NOTE FOR THE RECORD**DISCUSSION AT DSG SITE RESTORATION SUB GROUP ON WEDNESDAY 3 NOVEMBER 2021 AT 1930 HRS ON DOUNREAY LOW LEVEL WASTE FACILITY: DSRL'S APPLICATION TO VARY PERMIT**

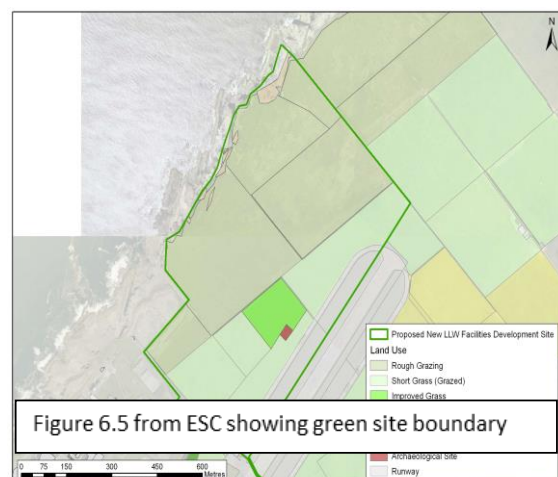
- Q9: Figures in the ESC 2020 D3100/4/REP/GAL/40137/IS/01 seem to suggest that the LLWF site location may be broadened. The figure below from page 127 suggests that the site may be broadening inland toward Buldoo, compared to the second image from Appendix E of the Supporting Document showing what we believe is the current boundary.

The green site boundary in the figure on the right is clearly part way across the old airstrip. The title in the figure reads “Proposed new LLW facilities development site” though this may be an old figure which has been reused.

Below Appendix E from Supporting Document D3100/4/REP/INT/40185/IS/02 showing D3100 facility boundary

The question is whether the site boundary is being considered to be revised toward Buldoo ?
